## Service Bulletin

**Subject:** Orange light on ProCal Snap with harness installed

**Applicable Models:** 2019+ Ram HD trucks using the AEV ProCal Snap

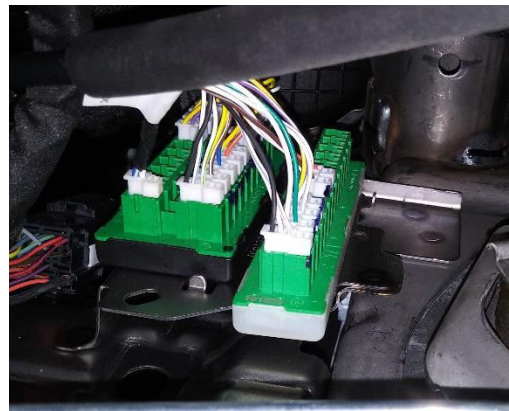
**Condition:** Orange light on with harness plugged in and ignition in RUN, possible odd behavior from vehicle such as auto steps not working

**Diag/Repairs:** Certain trim levels of Rams have more than one green Star connector. If this is the case, one will have a single row of plugs while the other will have two rows; the harness needs to be plugged into the two-row connector as shown.

In order to remove the white plug and move it over to the other Star connector, there is a small retaining tab off to the side inside the square without wires in it. The tab needs to be pushed towards the wires in order to remove the plug.
